SUBJECT: Responds to NRC request for addl info re proposed plant spent fuel pool reracking & forwards proprietary Rev 1 to HI-88243, "Fluid Coupling in Fuel Racks..." & HI-91700, "Dynarack Validation...." Repts withheld (ref 10CFR2.790).

Donald C. Cook Nuclear Plant Units 1 and 2
Docket Nos. 50-315 and 50-316
License Nos. DPR-58 and DPR-74
SPENT FUEL POOL RERACKING
RESPONSE TO REQUEST FOR ADDITIONAL INFORMATION

ATTACHMENT 1 TO AEP:NRC:1146C

FIGURE 1

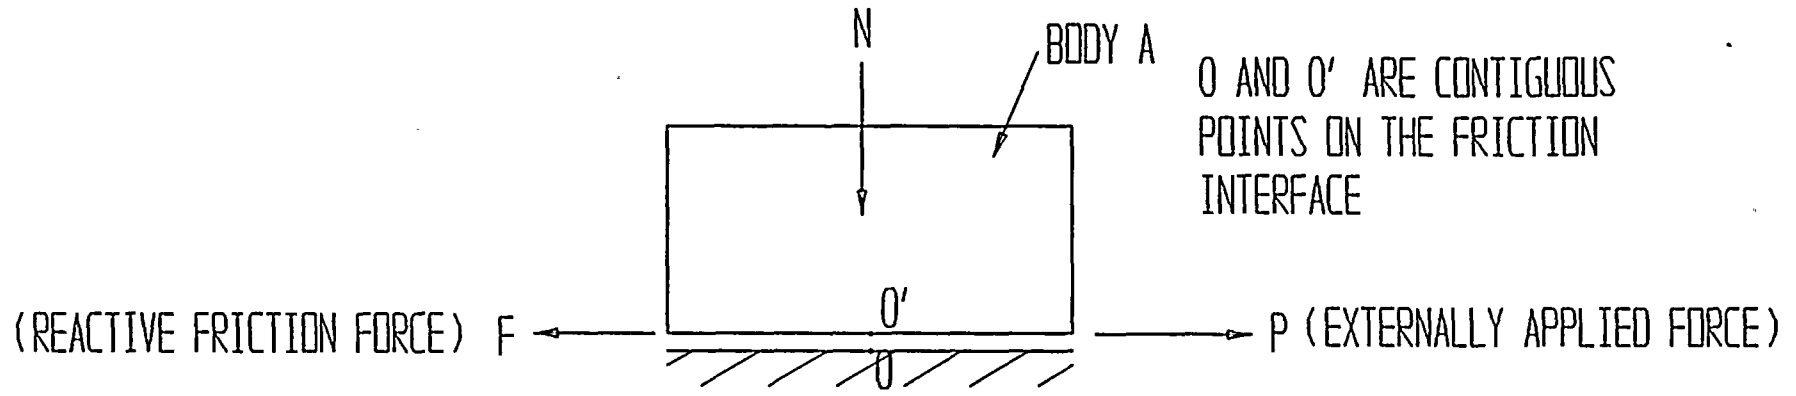
Question 3. "In pages 6-8, it is stated that the Coulomb friction between the racks and pool liners must be simulated by appropriate piecewise linear spring. Provide exact mathematical formulation of model and also discuss theoretical and experimental bases for the model. Discuss your representation of Coulomb friction damping with the model discussed in Reference 4 and explain the differences."

where N is the normal force on the friction interface, μ is the coefficient of friction and F is the supportable lateral force available from friction. The Coulomb friction force is reactive, rather than active. In other words, it develops only to counteract a laterally applied external force and its value cannot exceed the lesser of μN and the applied external force, P ; i.e., referring to Figure 1:

δ can be viewed as the slip between the point $0'$ and 0 at the friction interface in Figure 1.
